PIC GPIO: 14 destinations still missing

U4 / PIC16F18855 / 28-pin SOIC | Pin numbers are physical package numbers, not schematic drawing order.

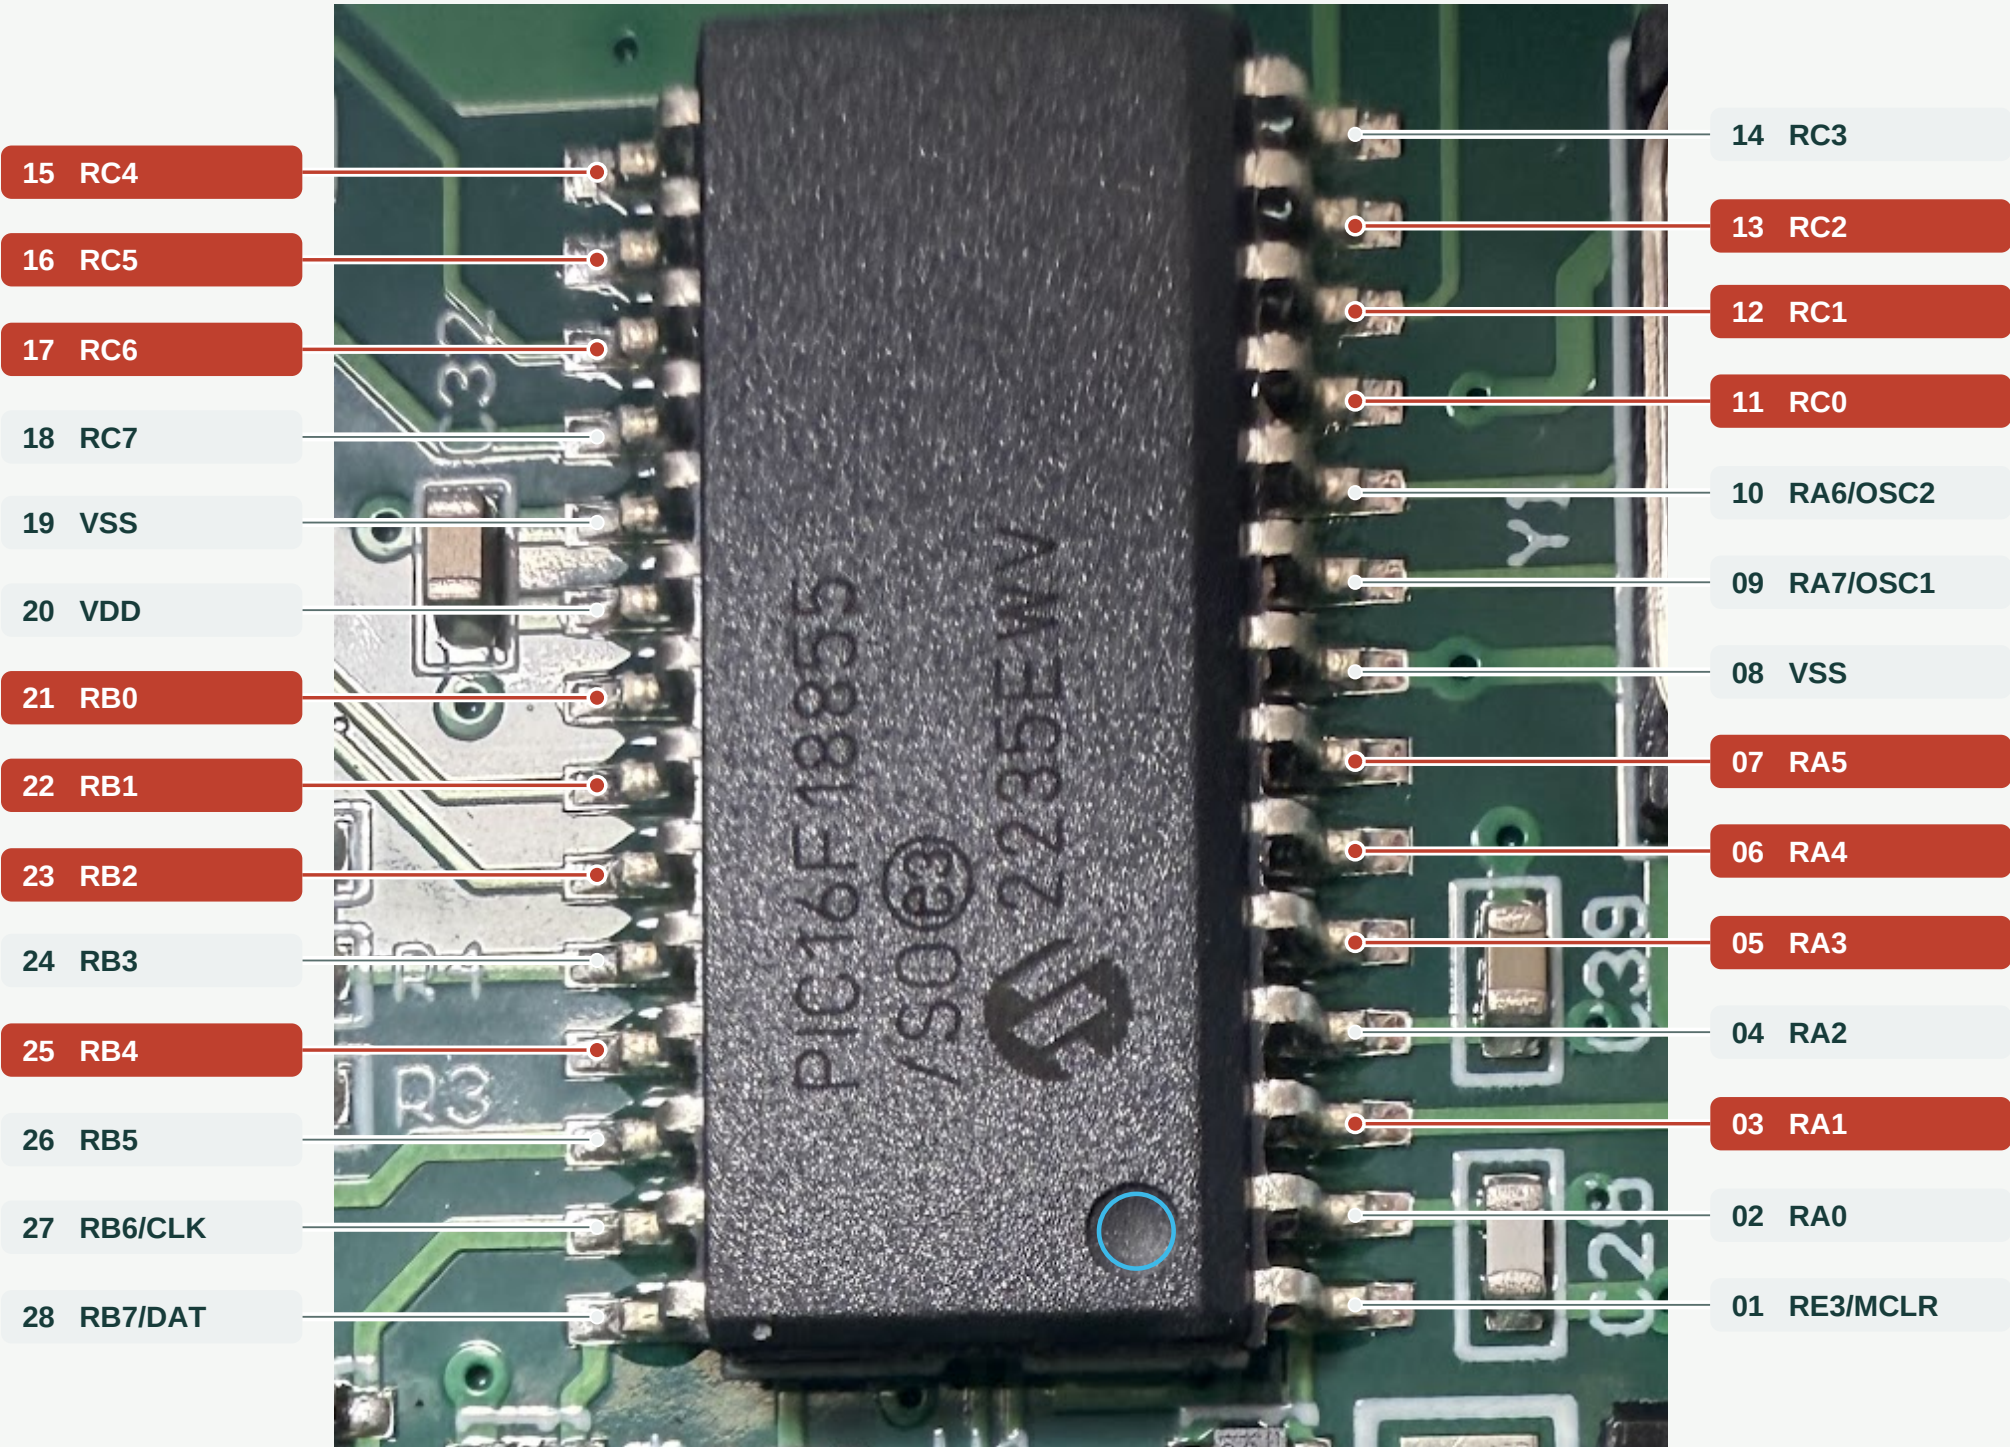
Orange = unresolved GPIO to trace Grey = already represented, sometimes still inferred

Orientation: pin 1 is at the lower right, beside the round moulded dot (blue ring).
Right row: bottom to top 1-14. Left row: top to bottom 15-28. Do not mirror the image.

Orange lines are callout leaders, not traced copper. Source: your new close-up; original photograph pixels retained.

Fill one or more destinations for each orange pin.

Pin	GPIO	Destination / pad / reading
3	RA1	
5	RA3	
6	RA4	
7	RA5	
11	RC0	
12	RC1	
13	RC2	
15	RC4	
16	RC5	
17	RC6	
21	RB0	
22	RB1	
23	RB2	
25	RB4
